APICAL INDUSTRIES, INC.
dba DART AEROSPACE

ENGINEERING CHANGE NOTICE NO.

DWG NO. 647.7700

DWG TITLE: STRUT ASSY

SHEET 2, ZONE D4 IS:

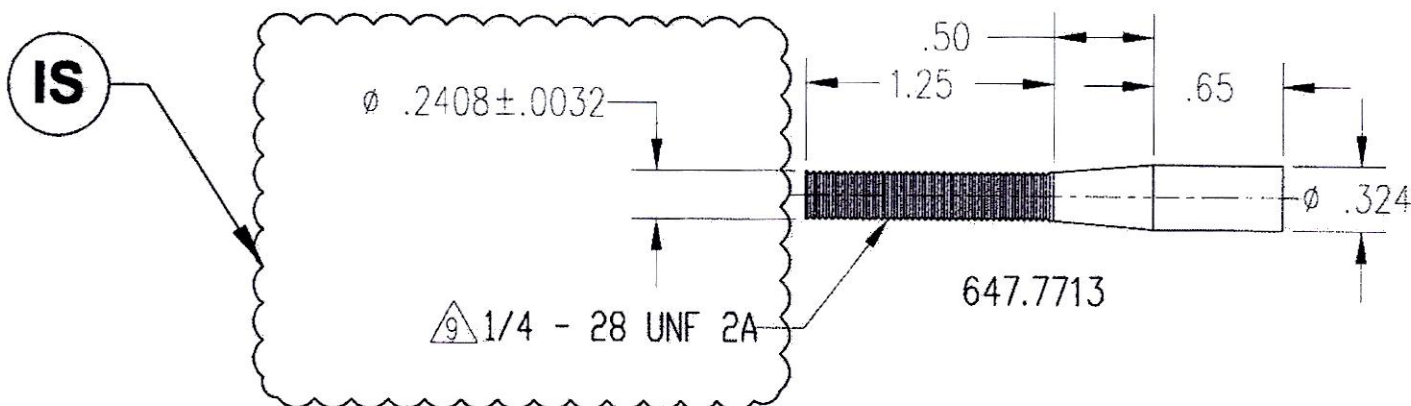
REASON: REVISED DIMENSION

1.
